**PLANNING COMMISSION AGENDA
MAY 5, 2022 – 6:30 P.M.**

**Planned Unit Development – Lots 23-26 Southport
West and portions of Lot 1 Southport West Replat
Four – Southport West Partners, LLC**

RE: Planned Unit Development Amendment – Initial Review Letter
Lots 23-26 Southport West and Lot 1 Southport West Replat Four

Comment Response: PUD Southport West -Letter dated 4/06/22

drawn by	KA
checked by	BR
approved by	
QC'd by	
QC'd date	02/26/2014
drawing no.	031272
date	03/12/14
LA VISTA, NE	
SOUTHPORT WEST REPLAT NINE PUD	
PHASE 1	
EROSION CONTROL PLAN	
PUD PLANS	
SHEET C.3.0	
20220

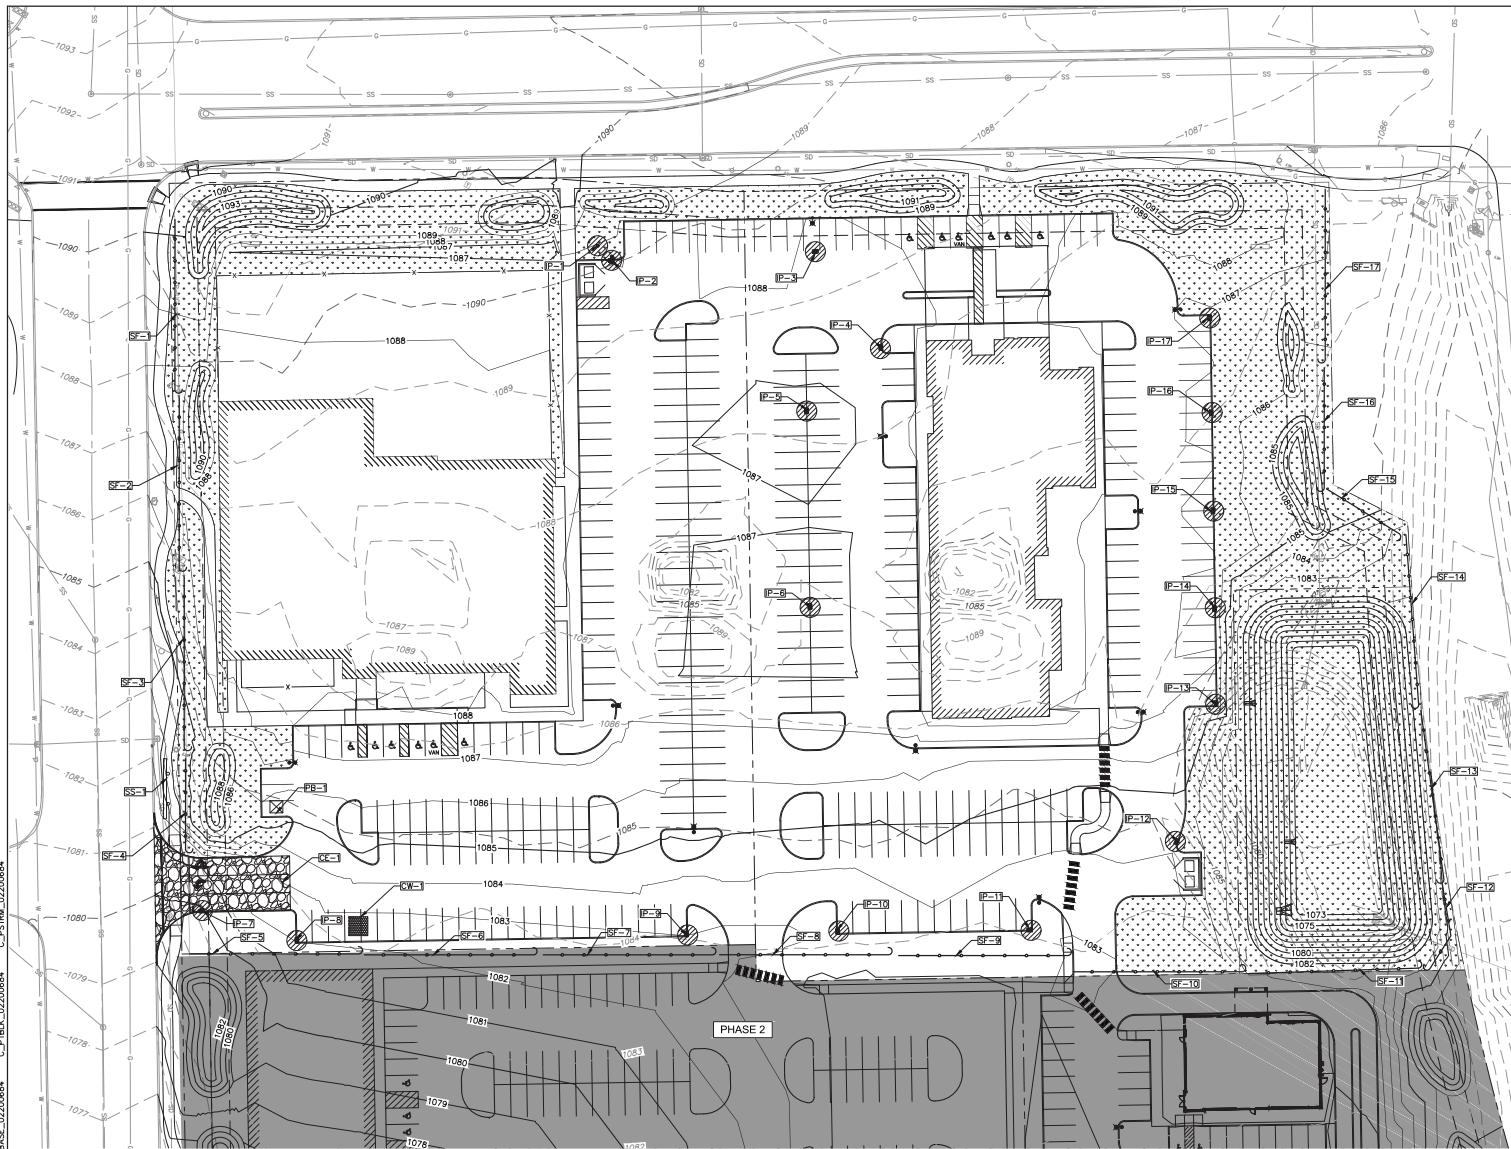
1. As discussed in the pre-application meeting, in an effort to push the northern two lots through the process as quickly as possible, the PUD plan set should concentrate on only the development of the northern two lots. Except for sheet C3.0, the PUD plan set should not include the site design below the southern lot line of lots 2 and 3.
2. Please revise the title of sheet C3.0 to "Conceptual PUD Phasing Plan" and change the phasing to only include lots 2 and 3 in Phase 1.

1. As discussed in the pre-application meeting, in an effort to push the northern two lots through the process as quickly as possible, the PUD plan set should concentrate on only the development of the northern two lots. Except for sheet C3.0, the PUD plan set should not include the site design below the southern lot line of lots 2 and 3.

Please revise the title of sheet C3.0 to "Conceptual PUD Phasing Plan" and change the phasing to only include lots 2 and 3 in Phase 1.

Response: Per discussions, the plans have been revised to reflect the design for the north 2 lots only and phasing clarification has been updated accordingly.

SITE KEY NOTES

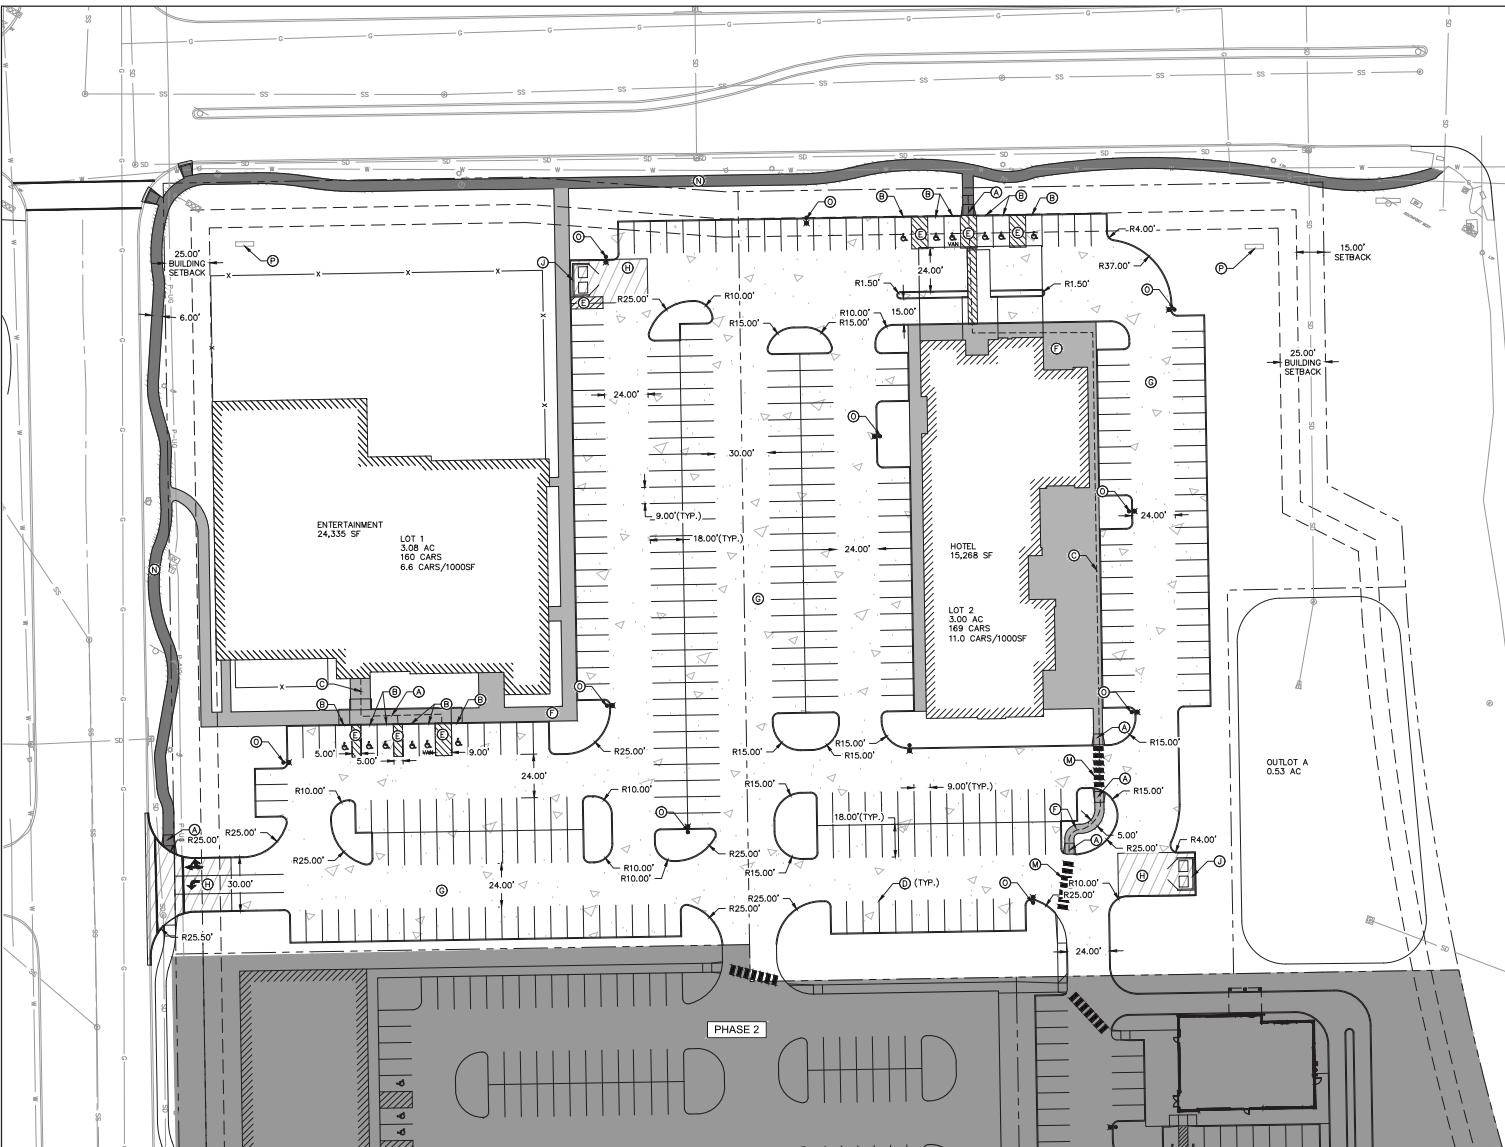
11. Sidewalk connections to buildings on lots 1, 2, and 4 need to be added for safe pedestrian connections to these developments, per Section 5.15.04.15.

11. Sidewalk connections to buildings on lots 1, 2, and 4 need to be added for safe pedestrian connections to these developments, per Section 5.15.04.15.

Response: Sidewalk connections have been added.

Papillion Fire truck
Overall Length
Overall Width
Overall Body Height
Min Body Ground Clearance
Track Width
Lock-to-lock time
Max Wheel Angle

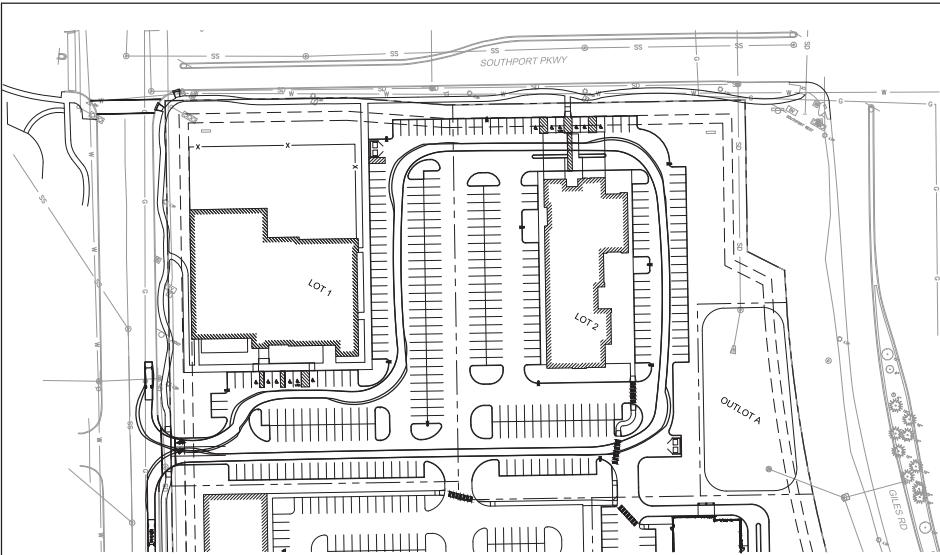
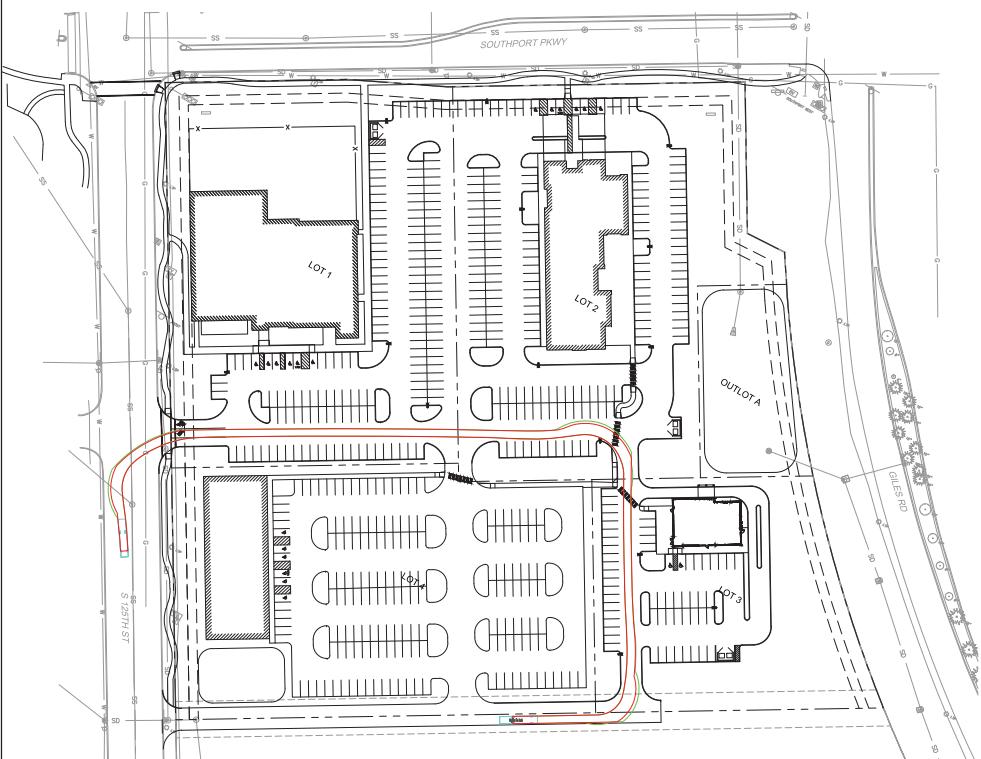
1. The Emergency Vehicle Access Plan doesn't adequately depict how the hotel on Lot 2 will be accessed.

1. The Emergency Vehicle Access Plan does not adequately depict how the hotel on Lot 2 will be accessed.

Response: This has been revised to show the path through the hotel site.
